REMARKS/ARGUMENTS

In the April 21, 2005 Office Action, the Examiner rejected Claims 1-3, 6, 8-9 under 35 USC § 102(e) as being unpatentable over Harumoto (US Patent No. 6,460,097); and Claim 4-5 under Iwasaki (US Patent No. 6,198,876). The Examiner also rejected Claims 7 and 10 under 35 USC § 103(a) over Harumoto in view of Iwasaki. Applicants thank Examiner Casiano and Primary Examiner Gaffin for the telephone interview that was conducted on June 16th, 2005, and a summary of the interview is provided below. Applicants have amended Claims 1-2 and 4-7, 9-10, cancelled claims 8 and 11, and added new Claim 12. Claims 1-7, 9-10 and 12 are now pending of which Claims 1, 4, 6 and 9 are independent claims. Applicants respectfully request reconsideration of the patentability of the claims of the present application in view of the amendments and the following remarks.

FIGURE 1B

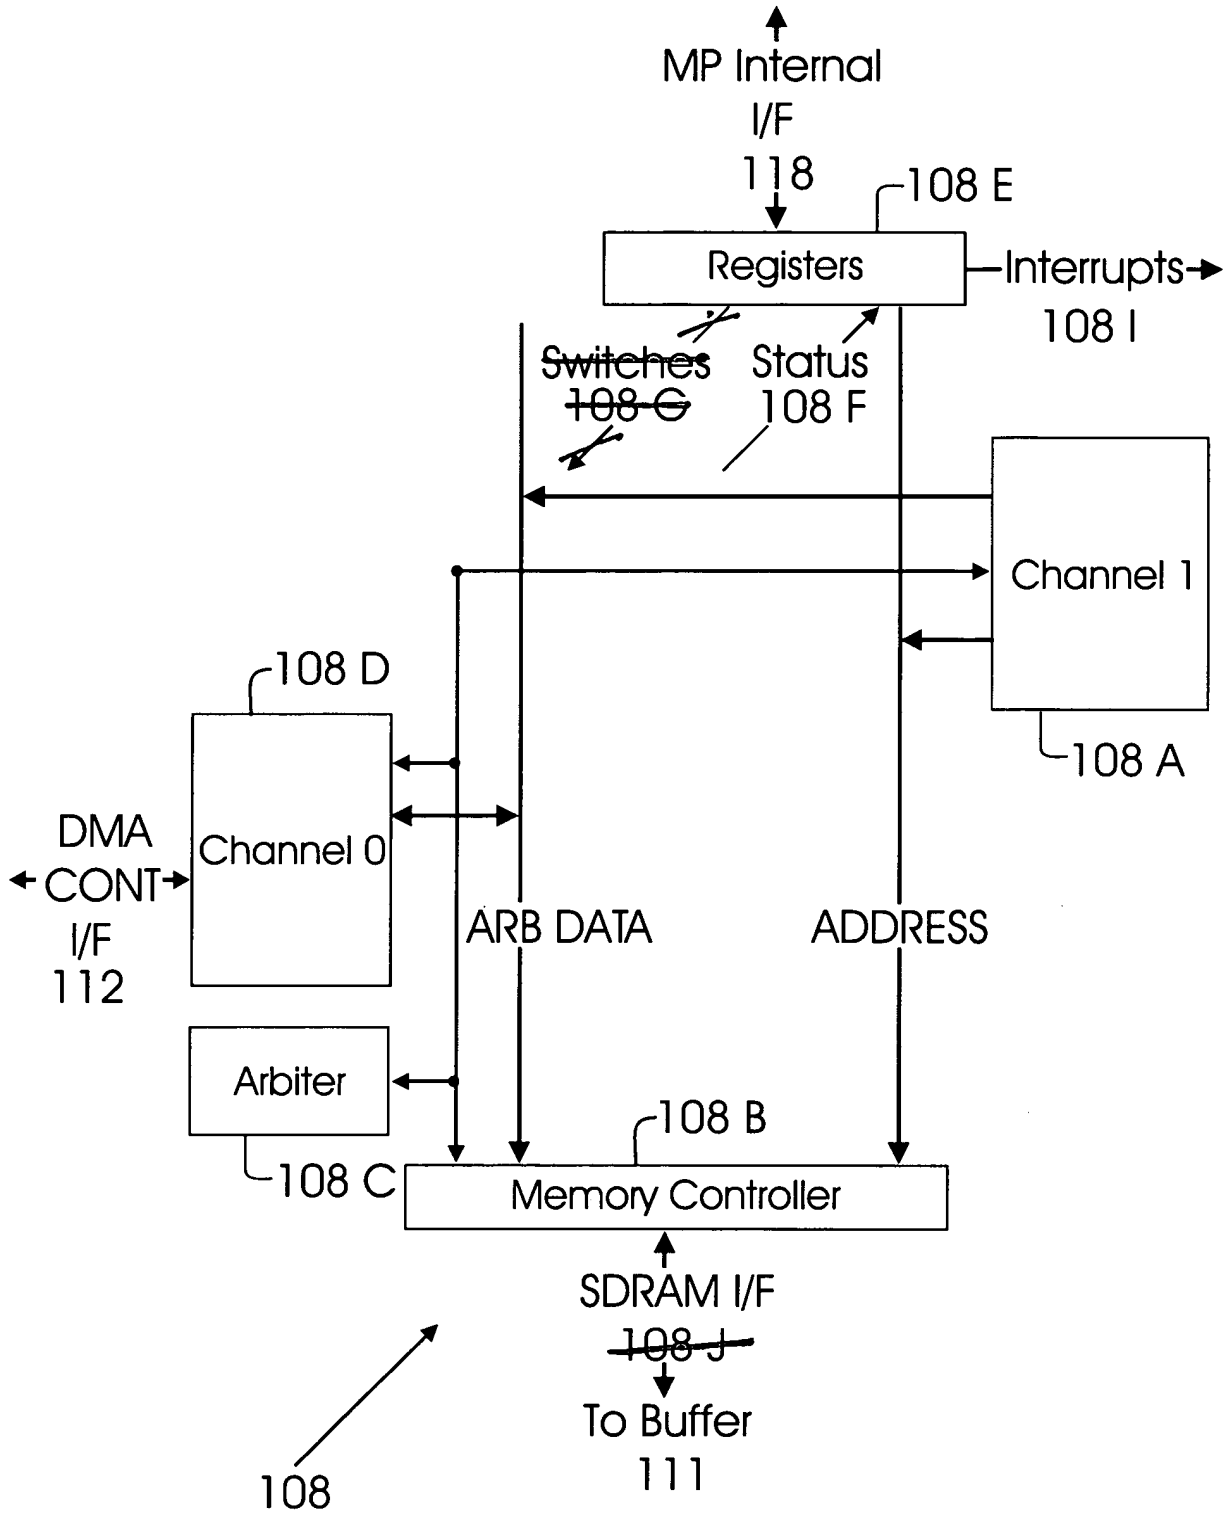
The Examiner had objected to the following figures:

Figure 1B: 108J, 108G, 108I and 108F

Applicants have amended paragraph [0038] to reference 108F and 108I in the specification. Applicants also submit substitute Figure 1B where reference to 108J and 108G has been removed.
